Section 00 9113 Addendum No. 2

SECONDARY WATER SUPPLY CITY OF FLINT, MICHIGAN

DIFFERENTIAL PRESSURE TRANSMITTER MOUNTING DETAIL

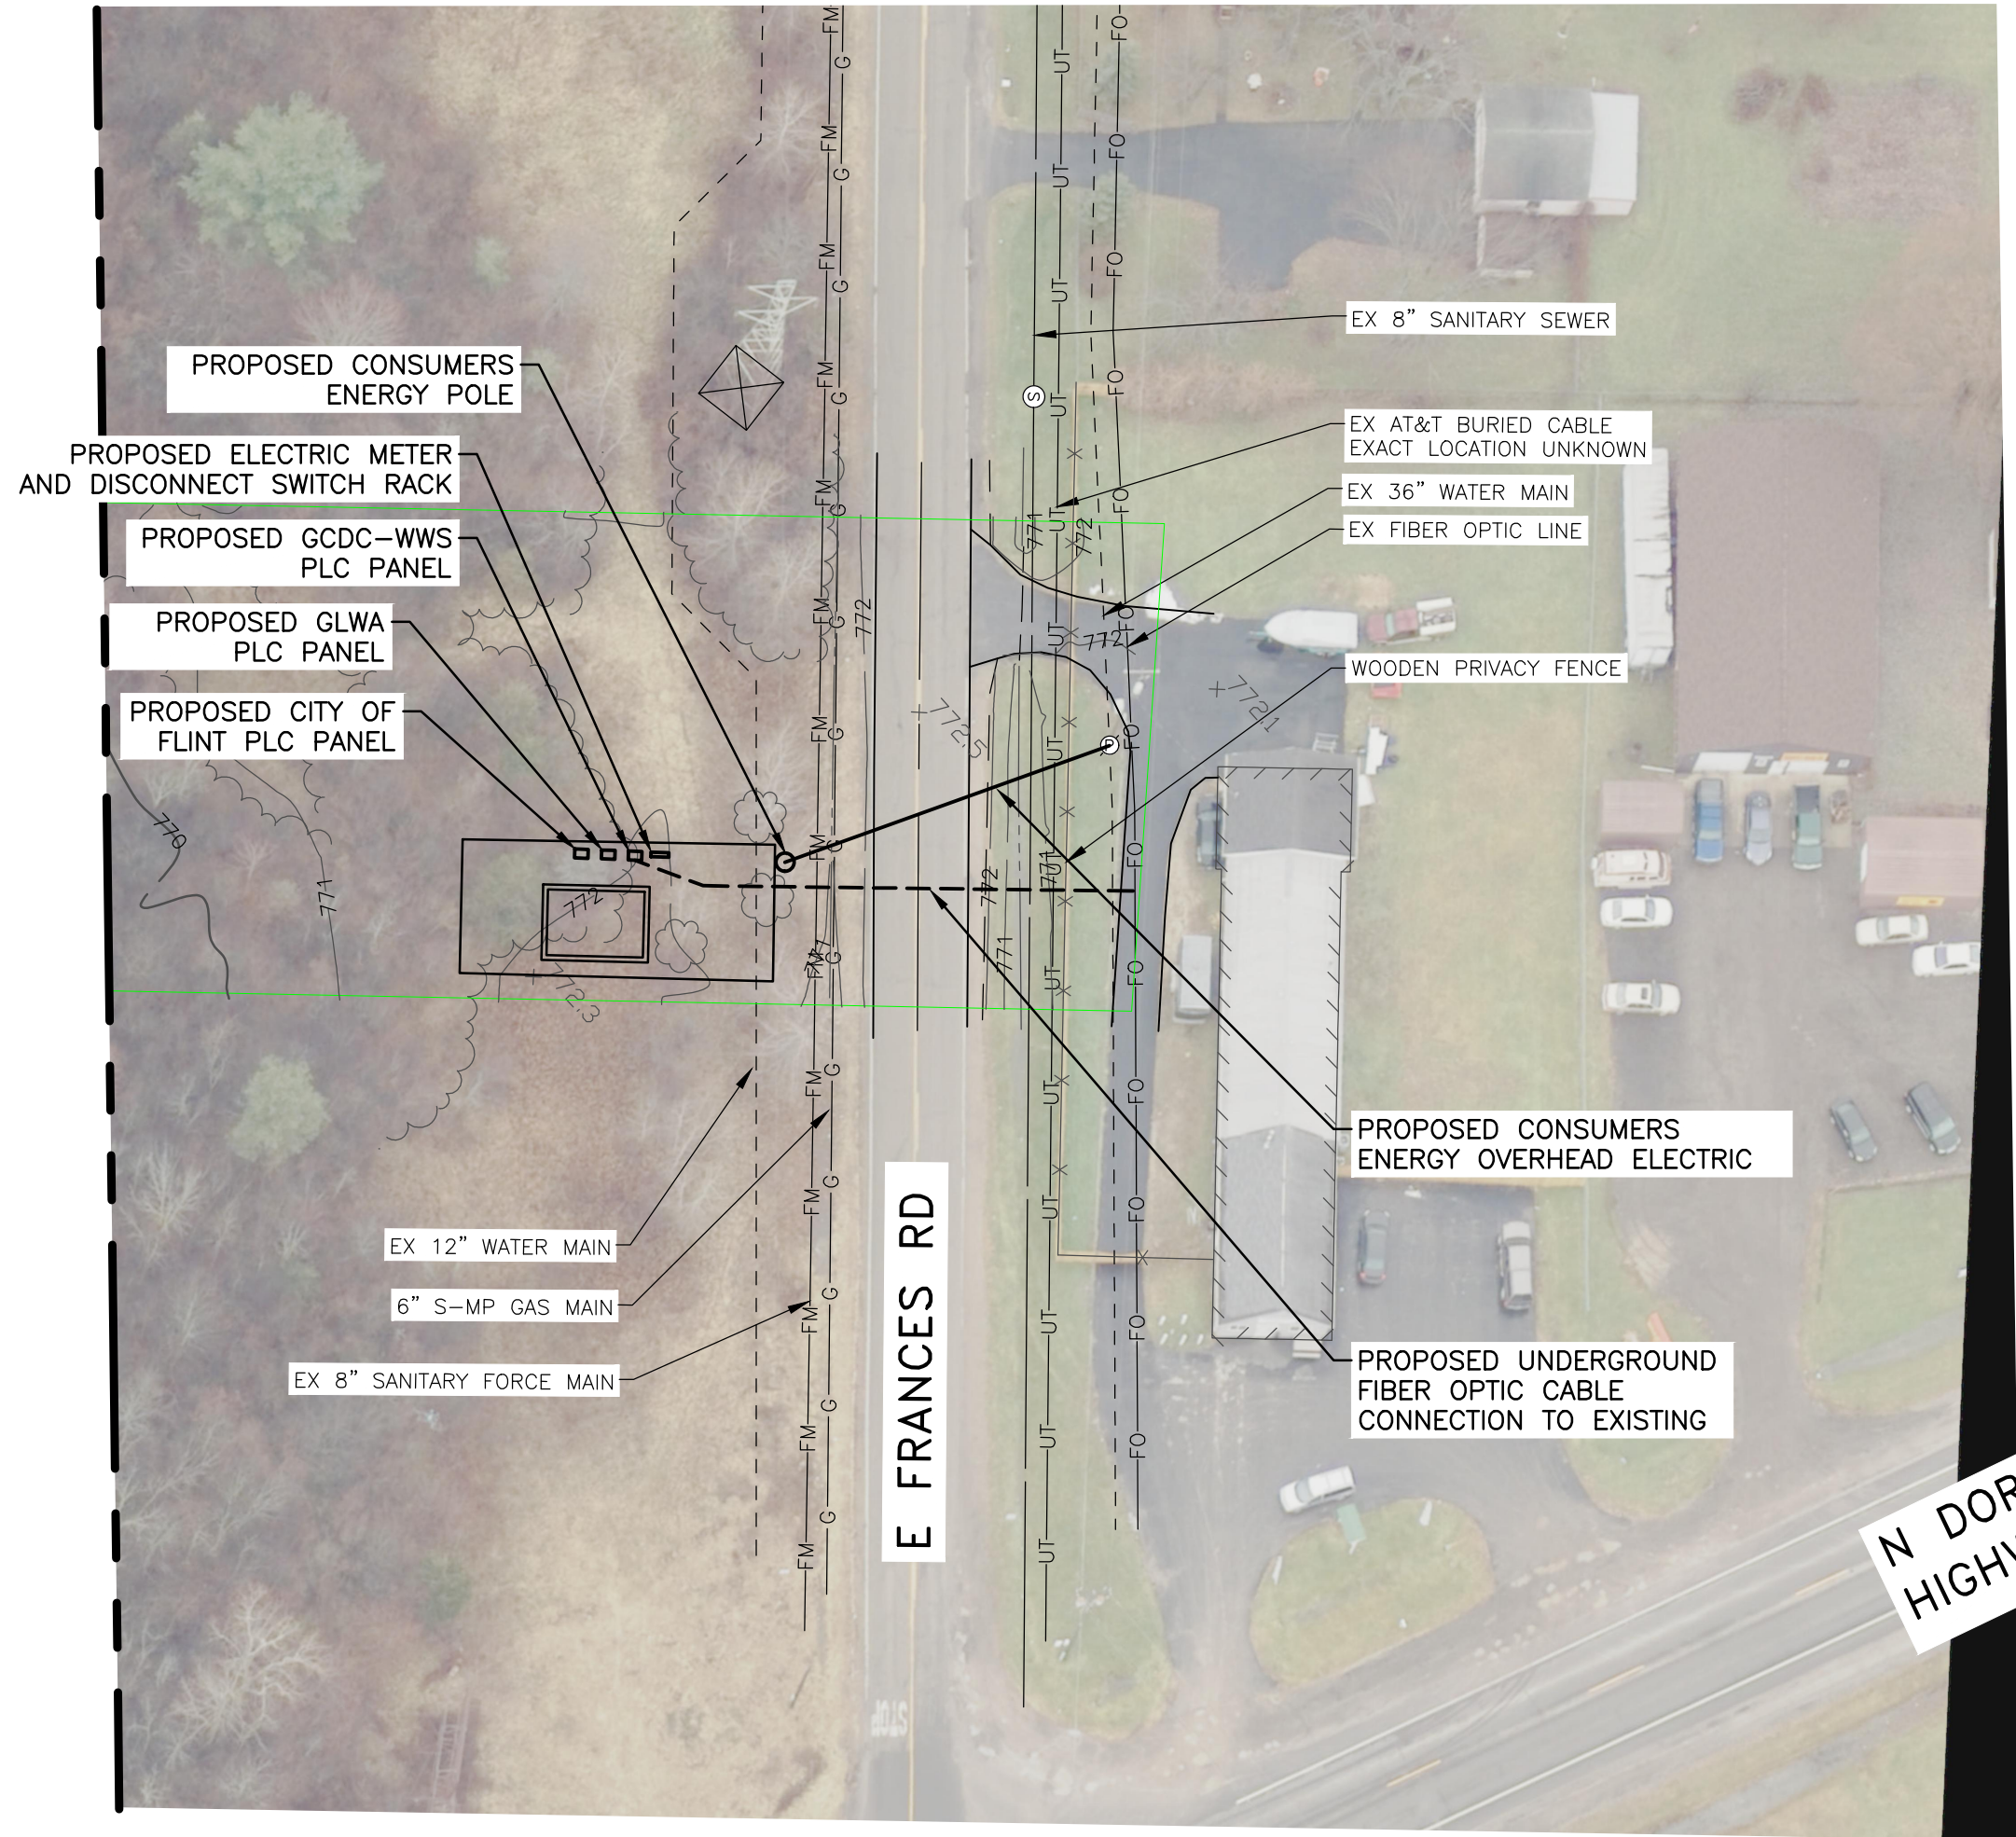
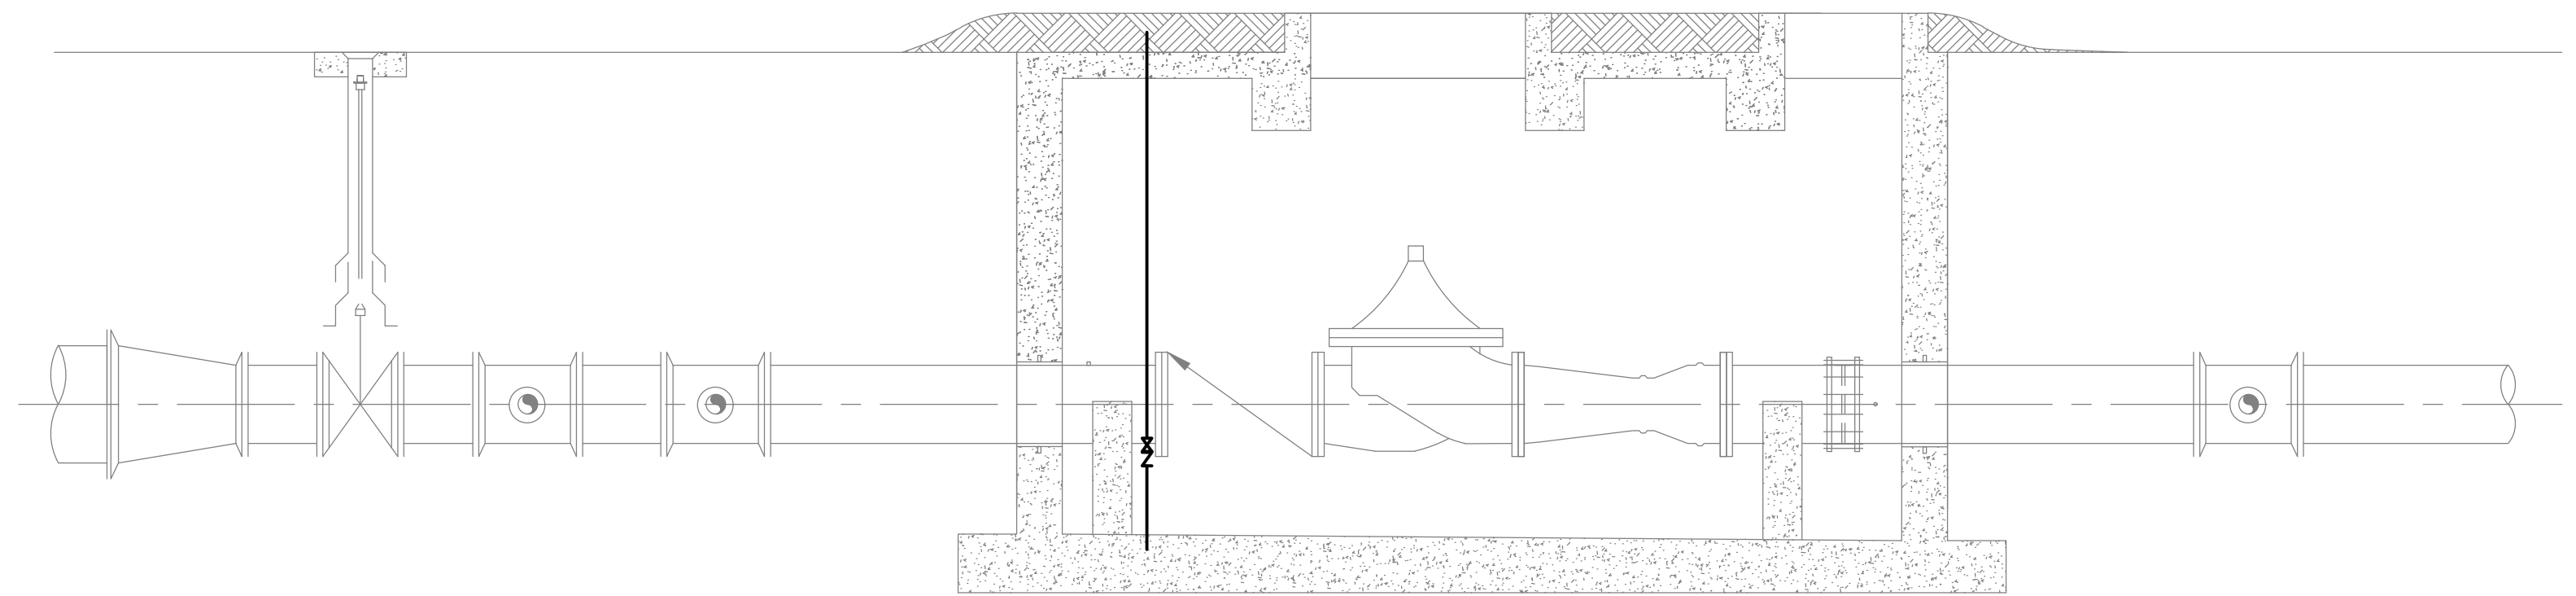
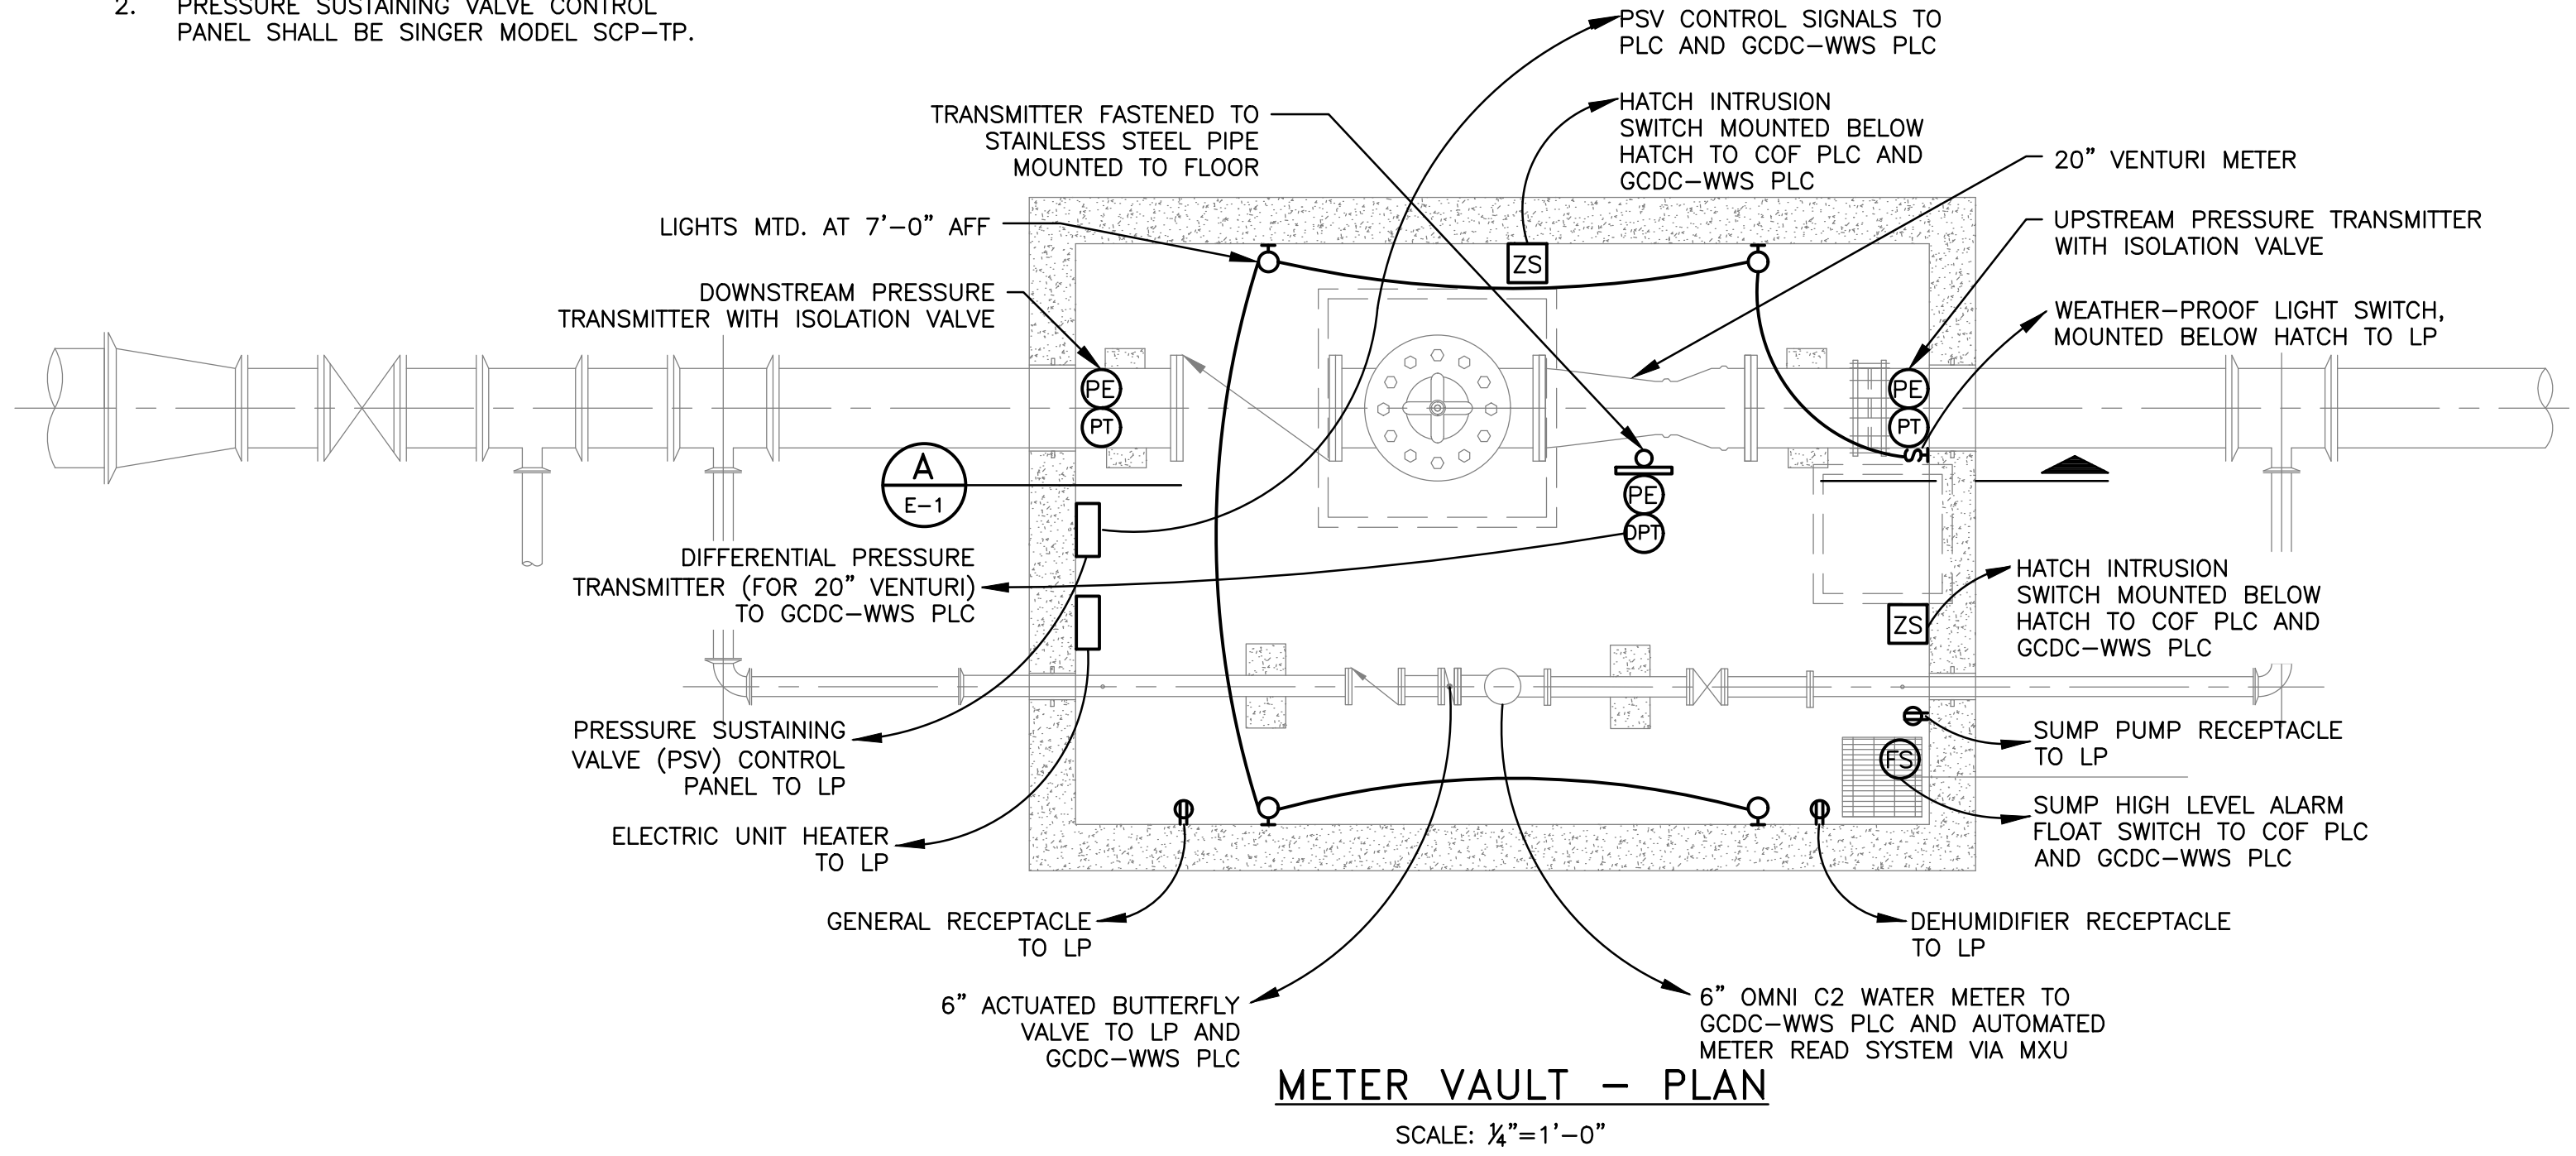
<u>Section</u>	<u>Description of Change</u>
40 7123.13	<p>Delete 1.02.B of Section 40 7123.13, Venturi Flow Meters, and add Article 2.01 as follows:</p> <p>2.01 Differential Pressure Transmitters</p> <p>A. General:</p> <ol style="list-style-type: none"> 1. Differential pressure transmitter shall provide up to ± 0.04 percent of reading and 14:1 flow turndown, 15-year stability, and manufacturer's 15-year limited warranty. 2. The transmitter shall be equipped with 316L stainless steel body and isolating diaphragm, 4-20 mA output with HART, stainless steel flange bracket, 316 stainless steel bolts, LCD display, transient protection, NSF drinking water approval, NEMA 4X aluminum housing, and 316 stainless steel 3-valve instrument manifold. <p>B. Acceptable Manufacturer:</p> <ol style="list-style-type: none"> 1. Rosemount 3051S3CD Ultra-For-Flow 2. ENGINEER-approved equal.
40 9000	<p>Modify Article 2.04.A.1.b of Section 40 9000, Process Instrumentation, Control and Monitoring Equipment, to read as follows:</p> <p>a. For work related to the City of Flint Water Treatment Plant, work shall be completed by:</p> <ol style="list-style-type: none"> (1) MAK Controls (2) Outbound Technologies (3) Progressive Controls and Instrumentation (4) Commerce Controls (5) ENGINEER-approved equal

1. DIFFERENTIAL PRESSURE TRANSMITTER SHALL BE ROSEMOUNT MODEL 3051S3CD2A3A11A1AC1M5D1Q4 WITH 3-WAY VALVE MANIFOLD MODEL 0305RC32B11B4.
2. PRESSURE SUSTAINING VALVE CONTROL PANEL SHALL BE SINGER MODEL SCP-TP.
